Office Action Summary

10/797,255

ROARTY, BRIAN P.

DETAILED ACTION

Gray French; Figure 1, page 67

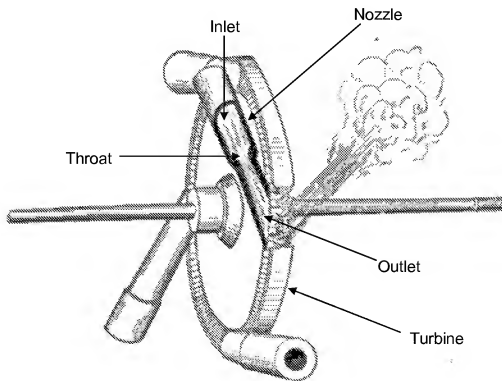
24. Regarding Claim 4, Gray French teaches a system comprising a nozzle having an inlet, a throat, and an exhaust (see figure below); a fluid flowing through the nozzle; and a means (i.e. turbine) for transforming the flow from the exhaust into work outside the system. Gray French fails to teach a means embedded within the nozzle for transferring energy into and heating the nozzle, thereby indirectly transferring energy into and heating the fluid and inducing a phase change in the fluid. Patterson teaches a means 38/44/36 embedded within a nozzle 12 for transferring energy into and heating the nozzle 12 (column 2, lines 15-17); thereby indirectly (through means 36) transferring energy into and heating the fluid and inducing a phase change in the fluid (column 3, lines 59-60).

25. Regarding Claim 5, Gray French teaches a system wherein the cross-sectional interior volume of the inlet, throat, and exhaust of the nozzle vary only across one plane perpendicular to the axis of the fluid flowing through the nozzle (see figure below).
